Economic Commission for Europe**Inland Transport Committee****World Forum for Harmonization of Vehicle Regulations****155th session**

**1958 Agreement – Consideration of draft amendments
to existing Regulations submitted by GRE****Proposal for 01 series of amendments to Regulation No. 113
(Headlamps emitting a symmetrical passing beam)****Submitted by the Working Party on Lighting and Light-Signalling***

The text reproduced below was adopted by the Working Party on Lighting and Light-Signalling (GRE) at its sixty-fifth session to change the basis for the photometric requirements from 12.0 V to 13.2 V and to update the requirements in line with technical progress. It is based on ECE/TRANS/WP.29/GRE/2010/5, not amended (ECE/TRANS/WP.29/GRE/65, para. 32). It is submitted to the World Forum for Harmonization of Vehicle Regulations (WP.29) and to the Administrative Committee (AC.1) for consideration.

Figure 13

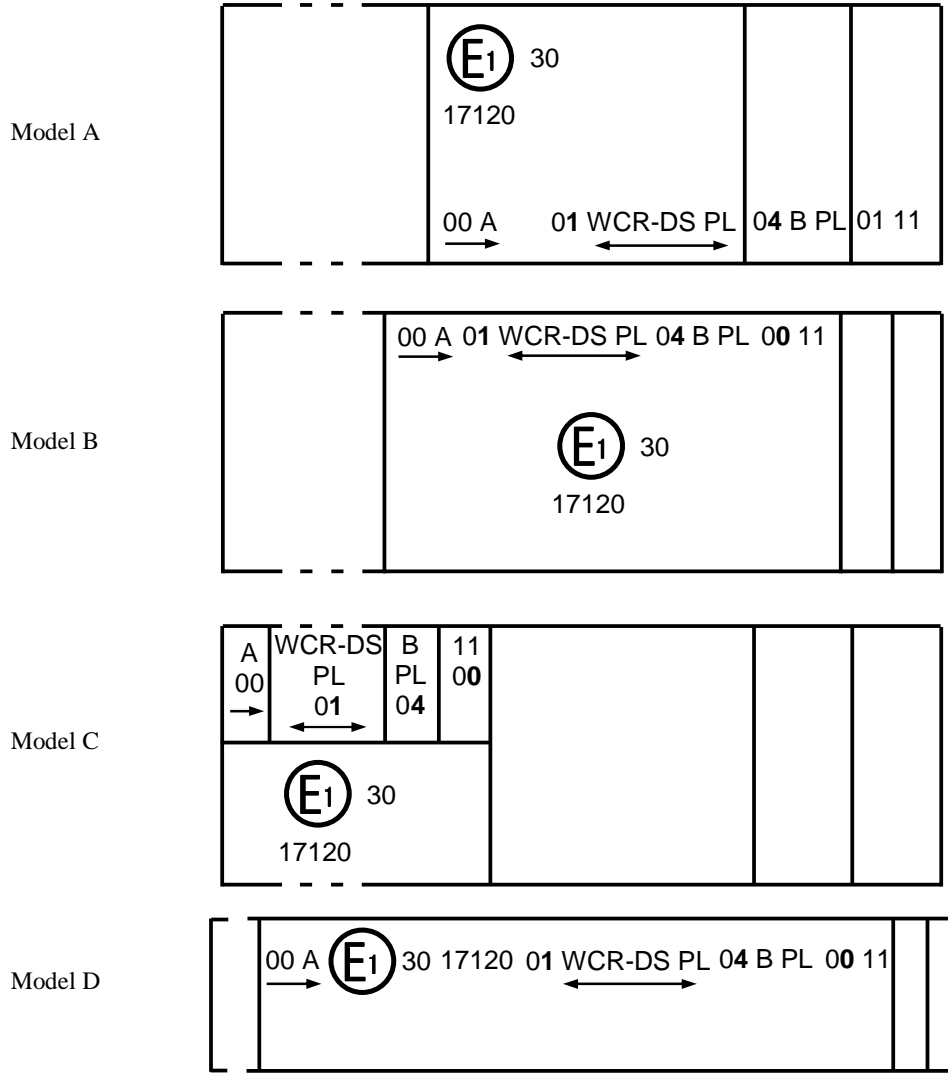
Simplified marking for grouped, combined or reciprocally incorporated lamps
(The vertical and horizontal lines schematize the shape of the light-signalling device. They are not part of the approval mark).

Note: The four examples above correspond to a lighting device bearing an approval mark comprising:

A headlamp, Class D, with a passing beam and a driving beam with a maximum intensity comprised between 123,625 and 145,125 candelas (as indicated by the number 30), approved in accordance with the requirements of this Regulation as amended by the 01 series of amendments and incorporating a lens of plastic material,

Figure 14

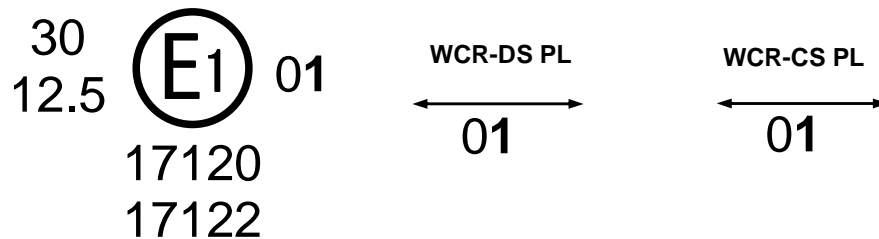
The above example corresponds to the marking of a lens of plastic material intended to be used in different types of headlamps, namely:

Either a headlamp, Class D, with a passing and a driving beam with a maximum luminous intensity comprised between 123,625 and 145,125 (as indicated by the number 30), approved in Germany (E1) in accordance with the requirements of this Regulation as amended by the 01 series of amendments, which is reciprocally incorporated with a front position lamp approved in accordance with Regulation No. 50 in its original form (00);

A headlamp, Class C, with a passing beam and a driving beam with a maximum luminous intensity comprised between 48,375 and 64,500 candelas (as indicated by the number 12.5), approved in Germany (E1) in accordance with the requirements of this Regulation as amended by the 01 series of amendments, which is reciprocally incorporated with the same front position lamp as above;

Figure A
Spherical Coordinate Measuring System

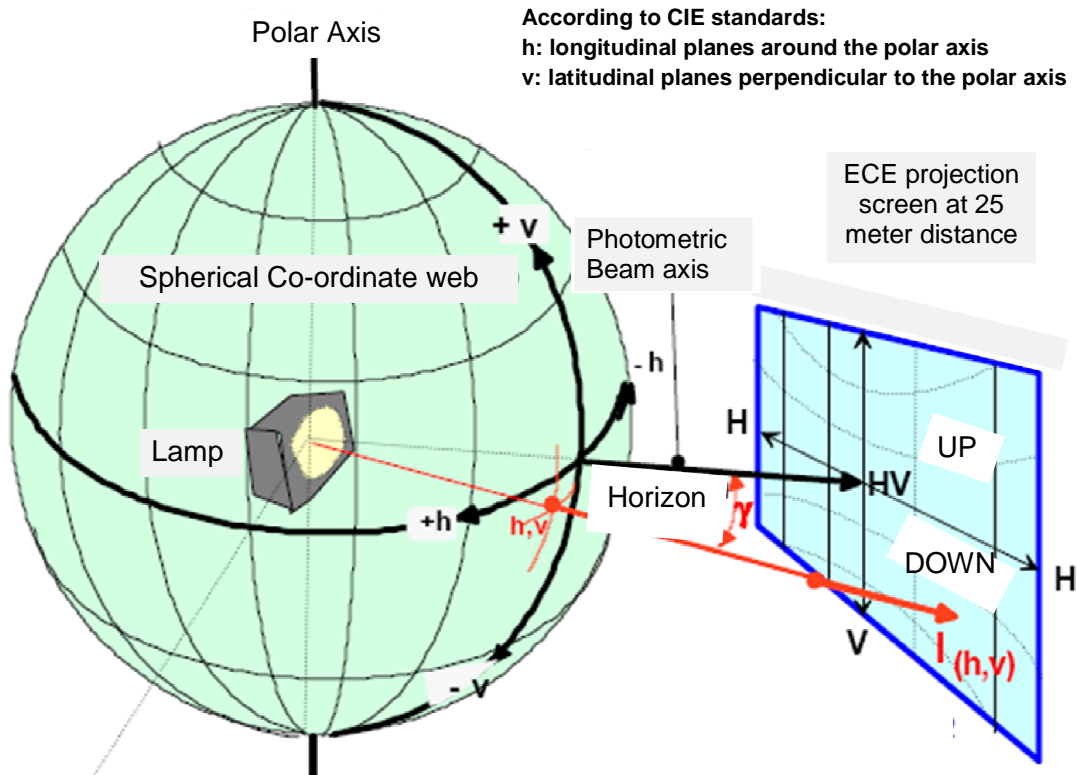
Annex 3, amend to read:

"Spherical Coordinate Measuring System and Test Point Locations

The angular co-ordinates are specified in degrees on a sphere with a vertical polar axis according to CIE publication No. 70-1987 "The measurement of absolute luminous intensity distributions", i.e. corresponding to a goniometer with a horizontal ("elevation") axis fixed to the ground and a second, moveable ("rotation") axis perpendicular to the fixed horizontal axis.

Figure B
 Passing beam - test points and Zones for Class A headlamp(s):

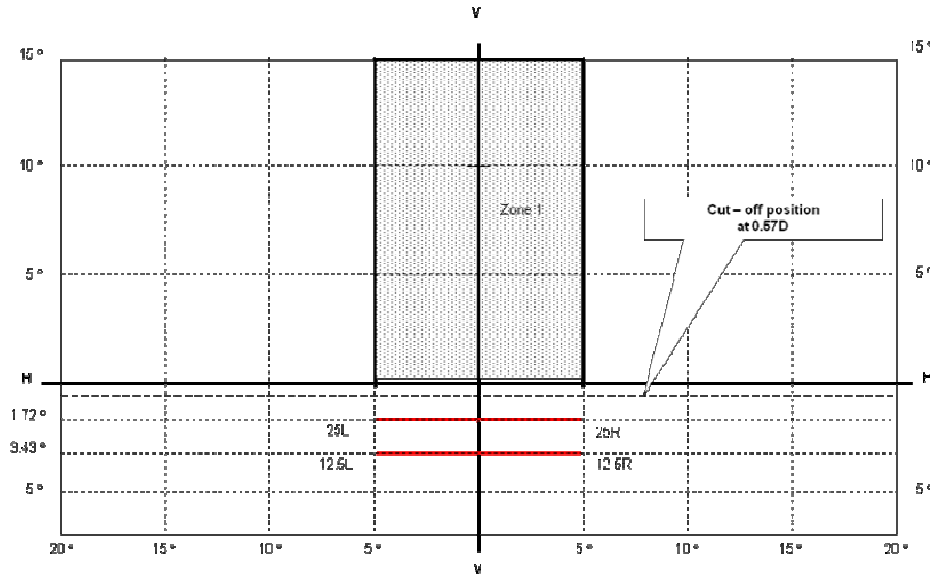
6.2.5.1. For Class A headlamps (Figure B in Annex 3):

<i>Test point/ line/ zone</i>	<i>Angular coordinates - degrees*</i>		<i>Required luminous intensity in cd</i>
Any point in Zone 1	0° to 15°U	5°L to 5°R	≤ 320 cd
Any point on line 25L to 25R	1.72°D	5°L to 5°R	≥ 1,100 cd
Any point on line 12.5L to 12.5R	3.43°D	5°L to 5°R	≥ 550 cd

Figure C
 Passing beam test points and Zones for Class B headlamp(s):

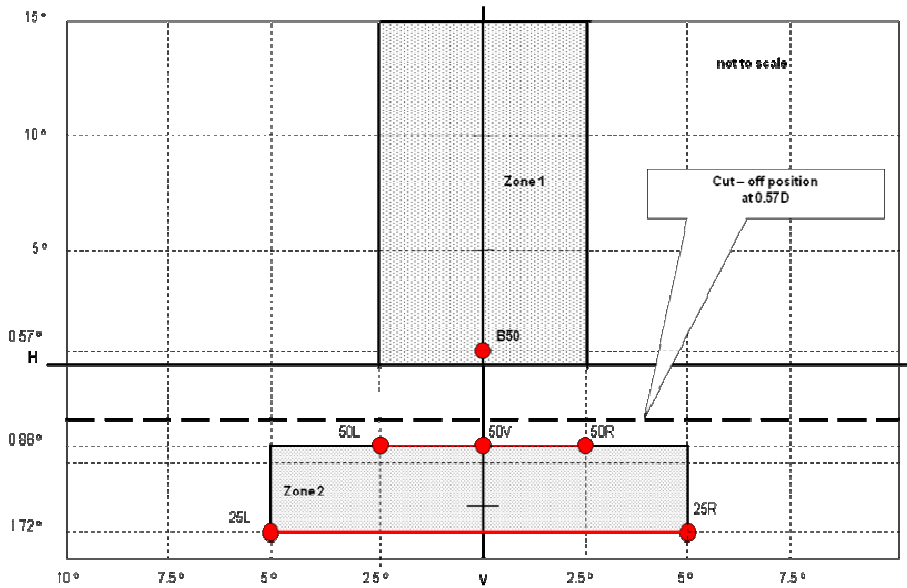
6.2.5.2. For Class B headlamps (Figure C in Annex 3):

<i>Test/point/ line/zone</i>	<i>Angular coordinates - degree*</i>		<i>Required luminous intensity in cd</i>
Any point in Zone 1	0° to 15°U	5°L to 5°R	≤ 700 cd
Any point on line 50L to 50R except 50V	0.86°D	2.5°L to 2.5°R	≥ 1,100 cd
Point 50V	0.86°D	0	≥ 2,200 cd
Any point on line 25L to 25R	1.72°D	5°L to 5°R	≥ 2,200 cd
Any point in Zone 2	0.86°D to 1.72°D	5°L to 5°R	≥ 1,100 cd

Figure D
 Passing beam - position of test points and zones for Class C, D and E headlamp(s):

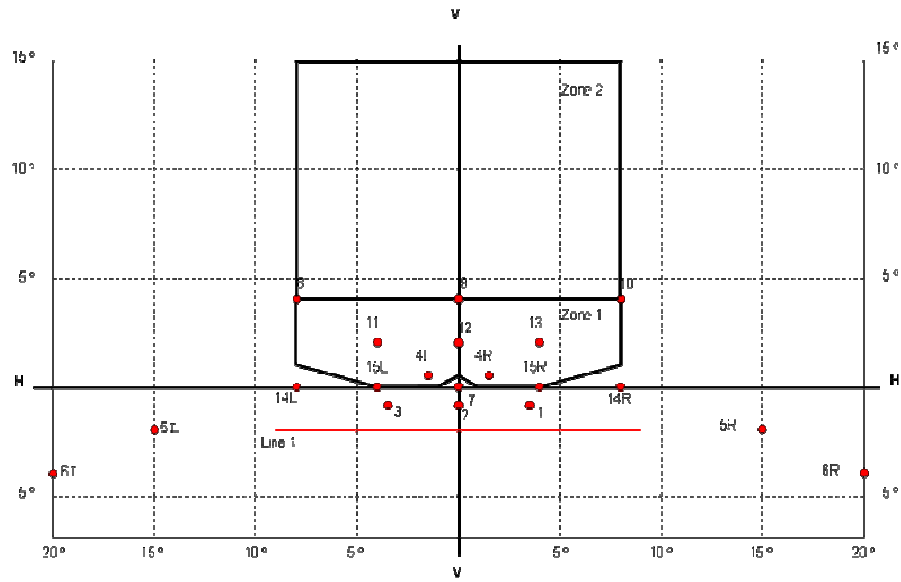
6.2.5.3. For Class C, D or E headlamp (Figure D in Annex 3):

Test point/ line/ zone	Test point angular coordinates - degrees*		Required luminous intensity in cd			
			Minimum			Maximum
			Class C	Class D	Class E	Class C,D,E
1	0.86°D	3.5°R	2,000	2,000	2,500	13,750
2	0.86°D	0	2,450	4,900	4,900	-
3	0.86°D	3.5°L	2,000	2,000	2,500	13,750
4	0.50°U	1.50°L and 1.50°R	--	--	--	900
5	2.00°D	15°L and 15°R	550	1,100	1,100	--
6	4.00°D	20°L and 20°R	150	300	600	-
7	0	0	--	--	--	1,700
Line 1	2.00°D	9°L to 9°R	1,350	1,350	1,900	-
8**	4.00°U	8.0°L	$\sum 8 + 9 + 10 \geq 150 \text{ cd}^{**}$			700
9**	4.00°U	0				700
10**	4.00°U	8.0°R				700
11**	2.00°U	4.0°L	$\sum 11 + 12 + 13 \geq 300 \text{ cd}^{**}$			900
12**	2.00°U	0				900
13**	2.00°U	4.0°R				900
14**	0	8.0°L and 8.0°R	50 cd**	50 cd**	50 cd**	-
15**	0	4.0°L and 4.0°R	100 cd**	100 cd**	100 cd**	900
Zone 1	1°U/8°L-4°U/8°L-4°U/8°R- 1°U/8°R-0/4°R-0/1°R-0.6°U/0- 0/1°L-0/4°L-1°U/8°L		--	--	--	900
Zone 2	>4U to <15 U	8°L to 8°R	--	--	--	700

Figure E
 Primary Driving Beam - position of test points

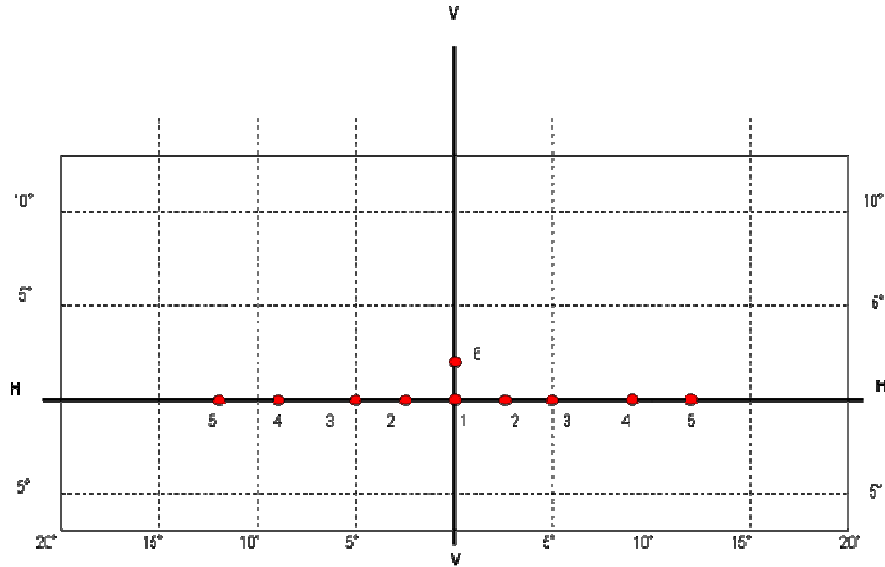
6.3.3.1. The luminous intensity of a Primary Driving Beam shall conform to the following table (Figure E in Annex 3):

Test point number	Test point angular coordinates - degrees*	Required luminous intensity [cd]					
		Class B		Class C		Class D, E	
		MIN	MAX	MIN	MAX	MIN	MAX
1	H-V	16,000	---	20,000	---	30,000	---
2	H-2.5°R and 2.5°L	9,000	---	10,000	---	20,000	---
3	H-5°R and 5°L	2,500	---	3,500	---	5,000	---
4	H-9°R and 9°L	---	---	2000	---	3,400	---
5	H-12°R and 12°L	---	---	600	---	1,000	---
6	2°U-V	---	---	1000	---	1,700	---
	MIN luminous intensity of the maximum (I_M)	20,000	---	25,000	---	40,000	---
	MAX luminous intensity of the maximum (I_M)	---	215,000	---	215,000	---	215,000

Figure F
Secondary Driving Beam - position of test points

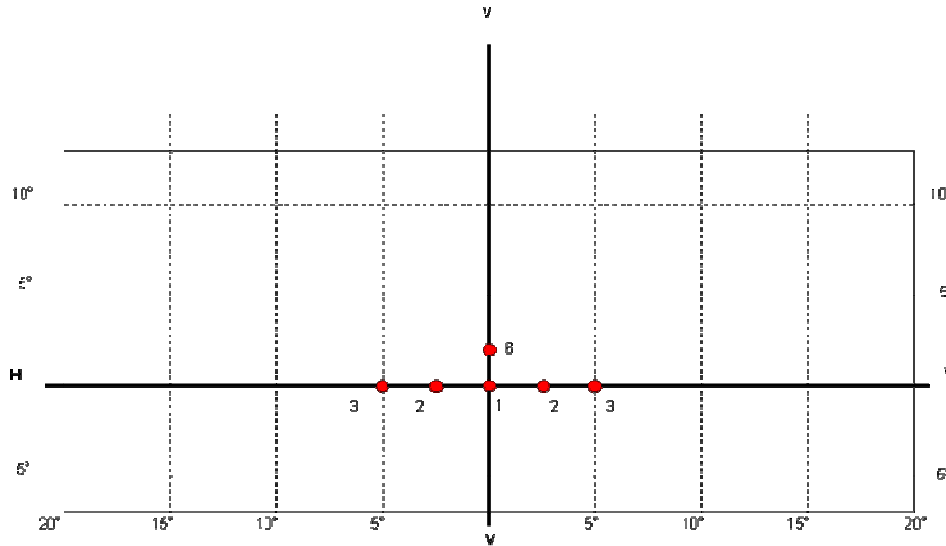
6.3.3.2. The luminous intensity of a Secondary Driving Beam shall conform to the following table (Figure F in Annex 3):

Test point number	Test point angular coordinates - degrees*	Required luminous intensity [cd]					
		Class B		Class C		Class D, E	
		MIN	MAX	MIN	MAX	MIN	MAX
1	H-V	16,000	---	20,000	---	30,000	---
2	H-2.5°R and 2.5°L	9,000	---	10,000	---	20,000	---
3	H-5°R and 5°L	2,500	---	3,500	---	5,000	---
6	2°U-V	---	---	1,000	---	1,700	---
	MIN luminous intensity of the maximum (I_M)	20,000	---	25,000	---	40,000	---
	MAX luminous intensity of the maximum (I_M)	---	215,000	---	215,000	---	215,000

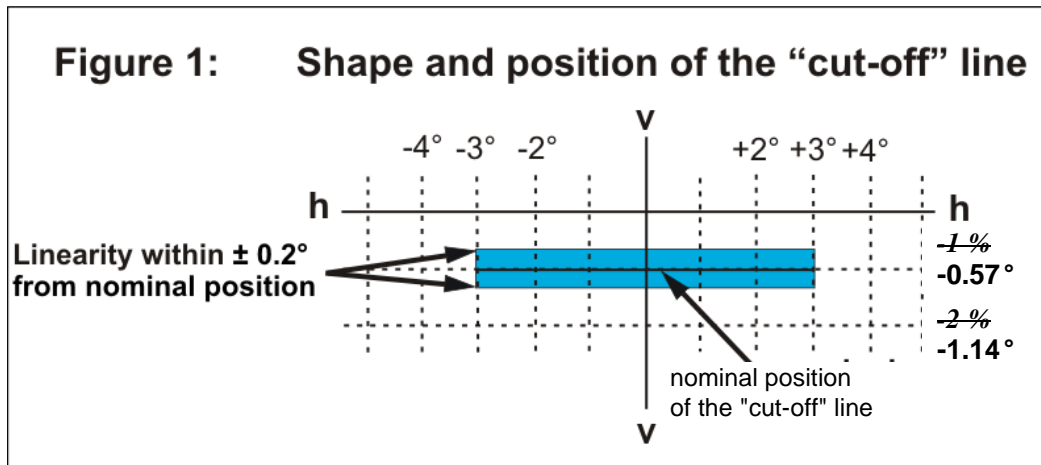
Annex 9, paragraph 2.1., figure 1, amend to read:
